MEMORANDUM

Location: O. S Grid Ref: 353 511 Land to the rear of 22 Bryn Estyn Road, Wrexham.

Development: Erection of 3 no. detached dwellings with associated garages, parking and access.

I refer to your consultation dated 21/02/2017 including layout plan (Drg. No. C077/012 Rev D – Dated Dec 2016) in respect of the above.

7.5t Panel Van
 Overall Length
 Overall Width
 Overall Height
 Min Body Ground Clearance
 Track Width
 Lock to Lock Time
 Kerb to Kerb Turning Radius

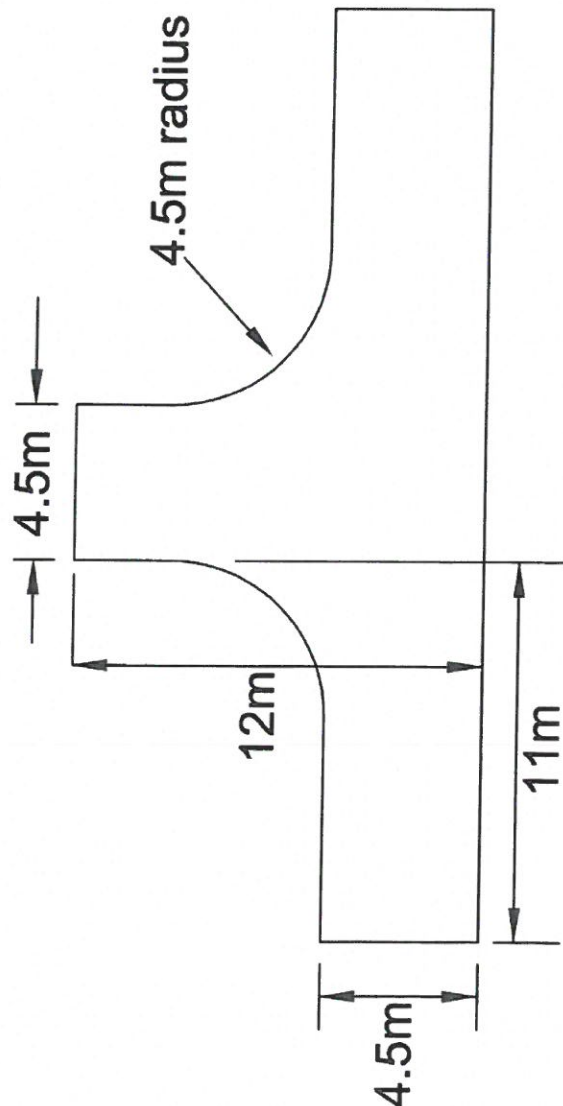
The proposed turning head indicated on the submitted layout plan is considered to be of insufficient size. I would recommend that a suitable turning head is provided off the private driveway which can accommodate the turning movements of a medium sized delivery vehicle (see attached detail). **I would recommend the submission of a revised layout plan indicating the above detail.**

PARKING AND DRIVEWAY ARRANGEMENTS

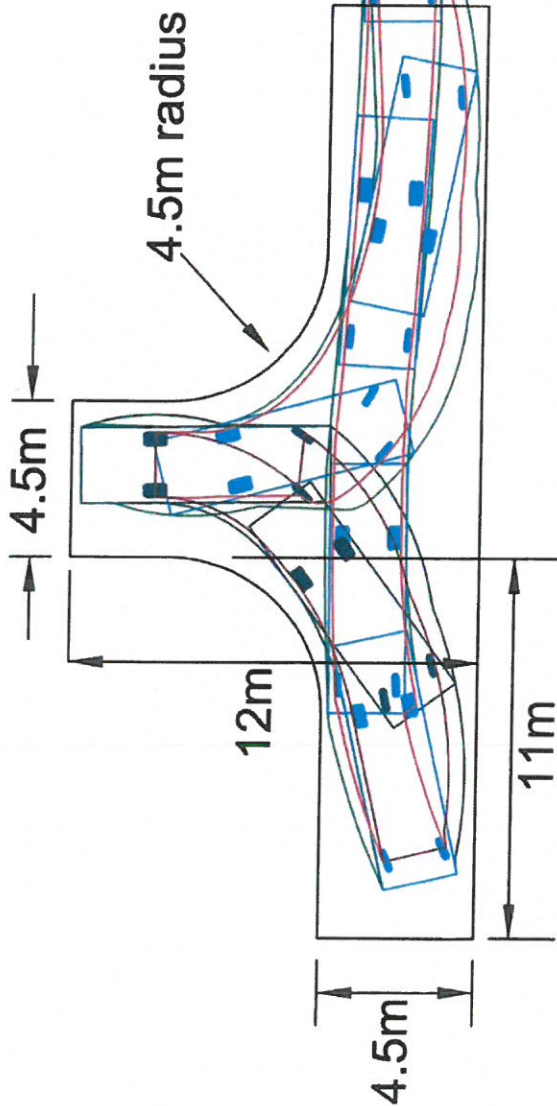
The proposed driveways do not comply with WCBC standard requirements (see attached detail). **I would recommend the submission of a revised layout plan indicating the above detail.**
